Remarks Section  
Application #10/667, 634  
Filing Date: 9/22/2003  
Re: Claims

**"Annotated Sheet"****Drawings****Dermawear: "Modified Men's Briefs"**

Application #10/667, 634

Figure 3C

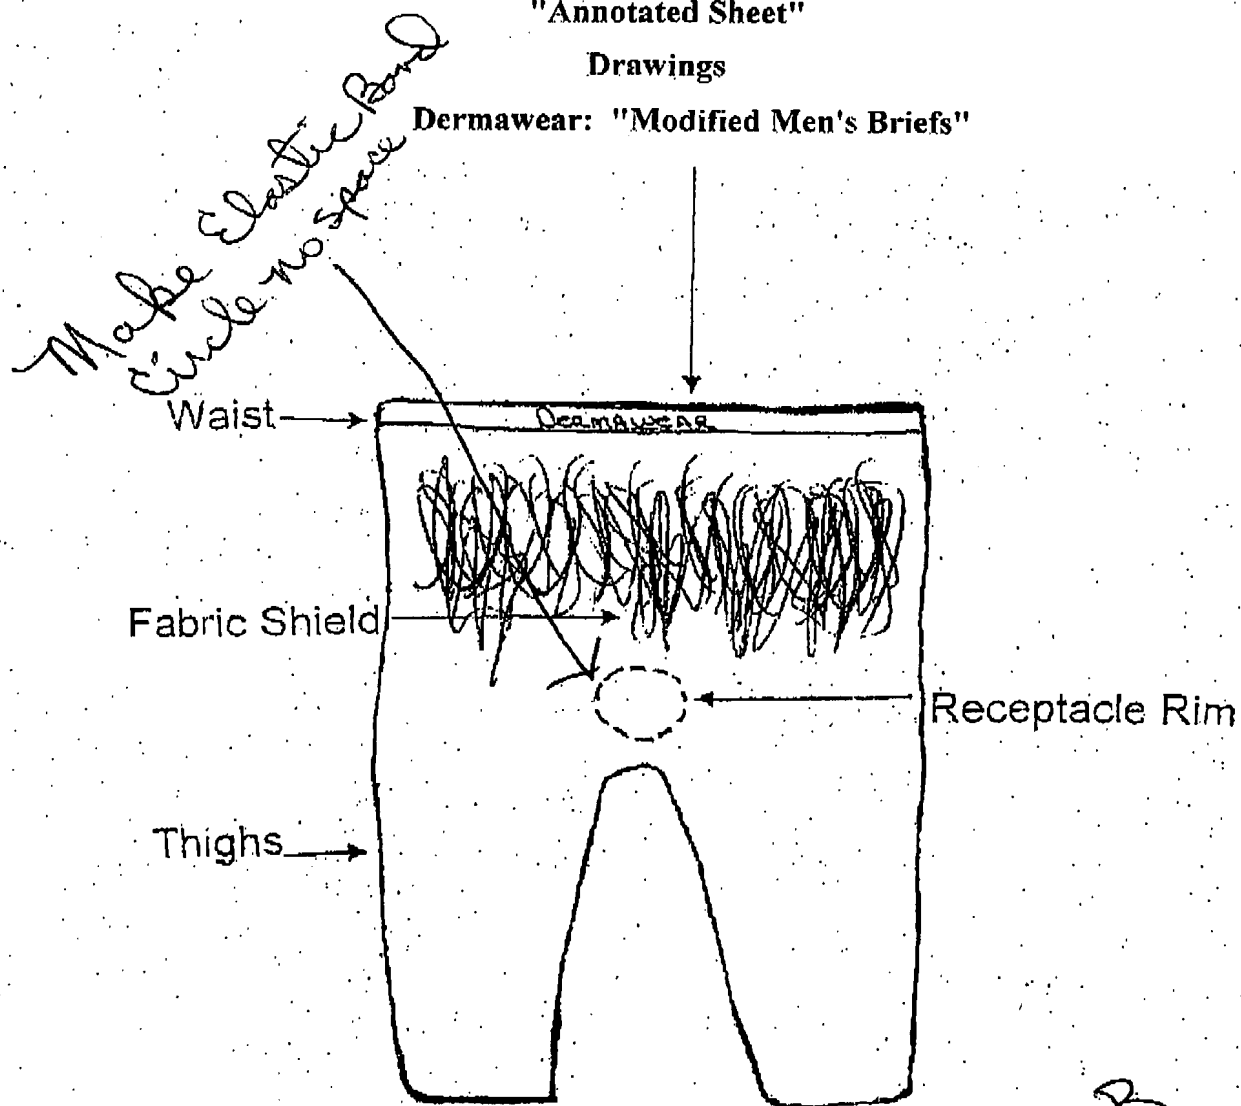
*Other Borders will not ~~work~~ work.*

*Figure 3C not needed for Dermawear*

~~Figure B2~~

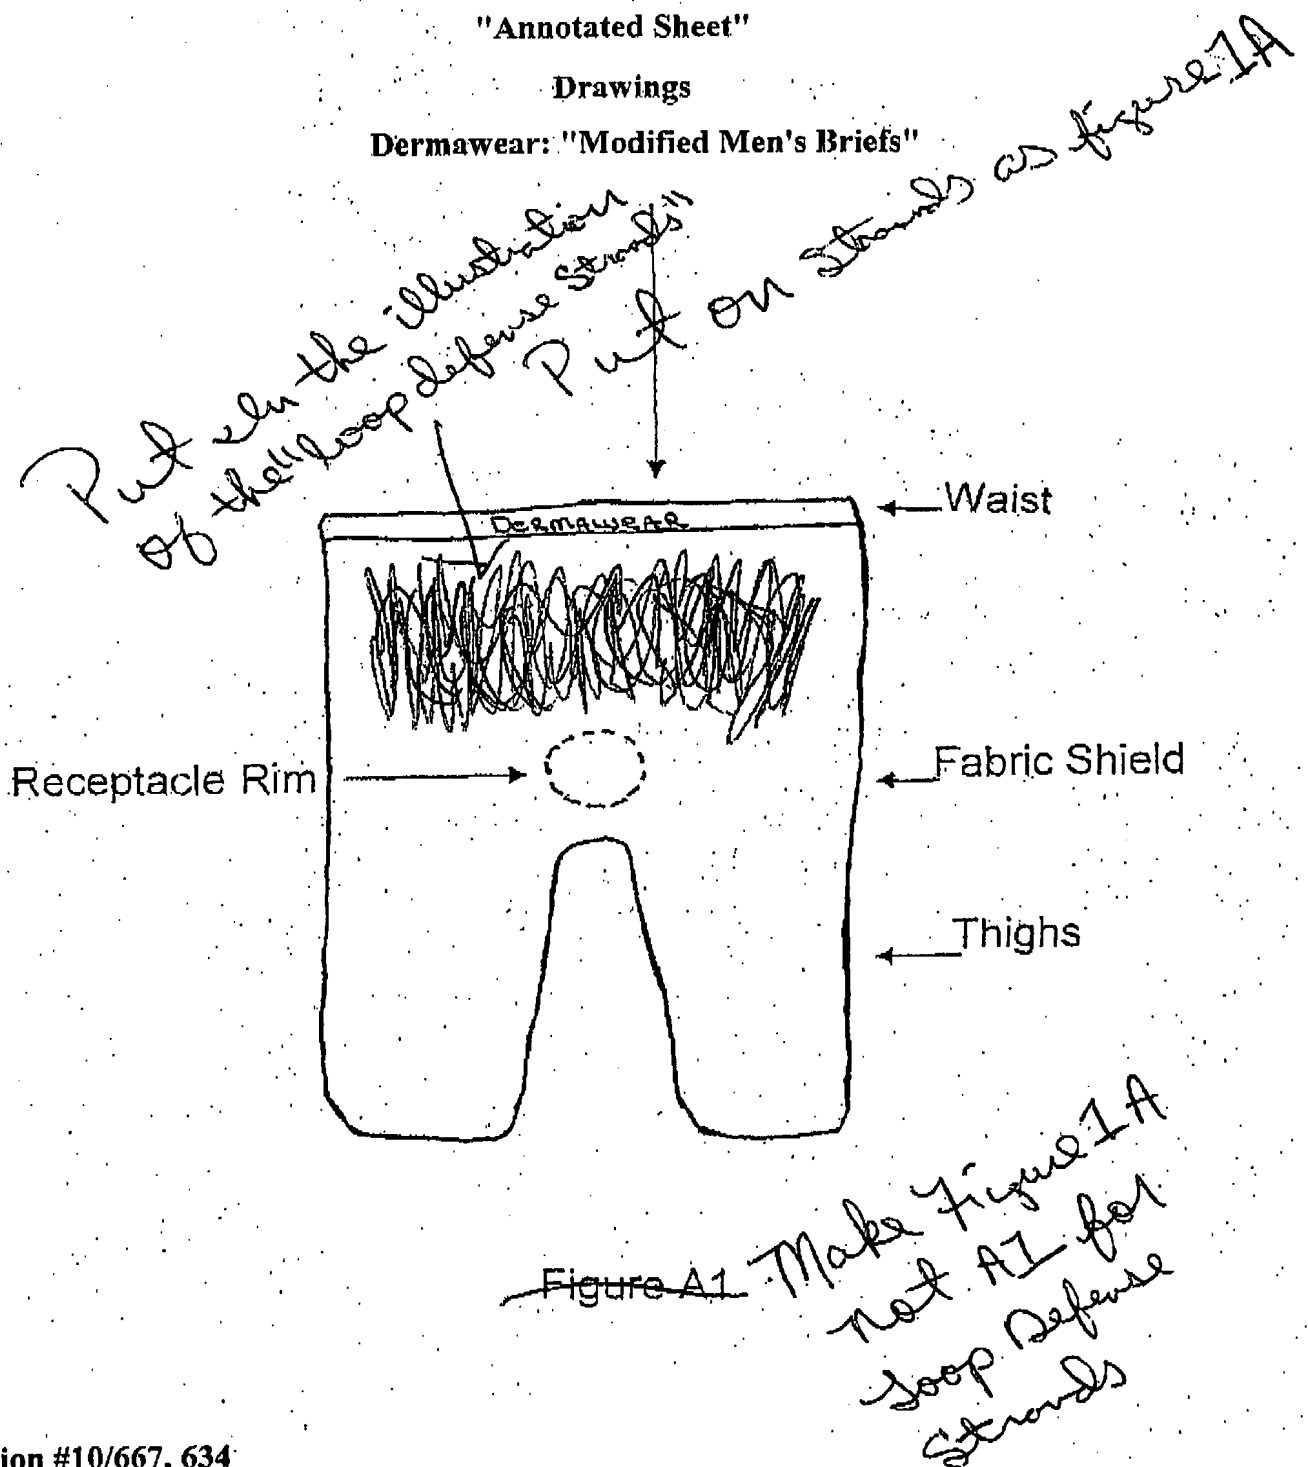
*Make Figure 2B  
not B2*
